From: Simon Nelson
Sent: 4/12/2023 10:07:46 AM
To: Council Northernbeaches Mailbox
Subject: TRIMMED Submi ion regarding DA2023/1395
Attachments: Objecrion to proposed DA2023 1395.pdf;

Re: DA 2013/1395 - 1010-1014 Pittwater Road Collaroy - Demolition works and construction of shop top housing

- Area of non-compliance with Section 3F-1 of the Apartment Design Guide (page 63 refers to Figure 3F.5)
- Visible area of non-compliance with WLEF Max height

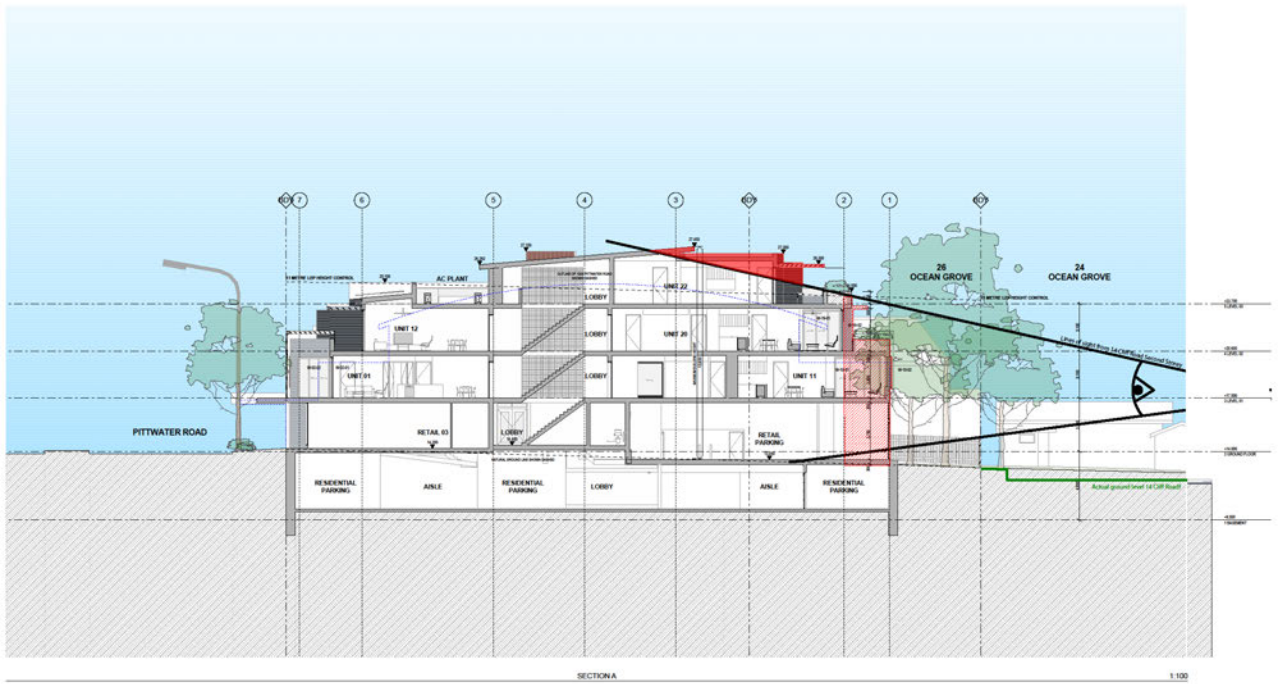
Rear setback – The proposed building is to be located 6m from our rear boundary. According to the Apartment Design Guide (SEPP65), because there is a change in density (from E1 to R2), the setback needs to be an additional 3m. As the ADG states that setback should be a minimum of 4.5m at GL, and 6m at L1 and above, the minimum setback for this project should be a total of 9m. In addition, L3 should be further setback. It should be noted that while the development at 1000 Pittwater Road is only set back 6m at GL, L1 and L2 (greater at L3) it was approved before SEPP65 was introduced and therefore it would be wrong to use that as a precedent for allowing the proposed scheme to breach this important setback requirement.

This breach has a number of direct impacts on our property. The increased mass so close to the boundary is inappropriate and imposing. It will destroy the enjoyment and amenity of our back garden. In particular as shown in the diagram below, the windows on L2 will provide direct views into our swimming pool where my wife and I play with our 2 daughters (red line), and which would not be visible if the correct setback was enforced (green line). The additional 3m setback required by the ADG would also increase privacy to our patio and habitable rooms in the house.

Height – The site is subject to an 11m height limit (WLEP). The proposed scheme breaches this height by 2.93m. It is both stated and implied that this height is “concealed” which is not supported by proper analysis. That analysis would show that the height can be seen from both our garden and first floor windows, with the bulk being more noticeable from the second storey windows as can be seen from the 2 drawings below. The amount of the height excess is limited by the bulk of L3, which itself needs to be reduced through greater setback, which would make the breach more visible. In order for a variation to be granted, the 2 top storeys would need to be substantially modified to reduce the bulk of the building and reduce the visual impact on my property.

Additional Storey – The proposed scheme proposes a 4th storey, one more than permitted. While I don't have any theoretical objection to this breach, it can only be allowed if it has no impact. The applicant states that it is a "concealed" storey, but the diagrams above disprove this notion. Therefore, I object to the extra storey as it will have an impact on my house, through greater visible mass and bulk. The same arguments used above under "height" apply to this additional storey.
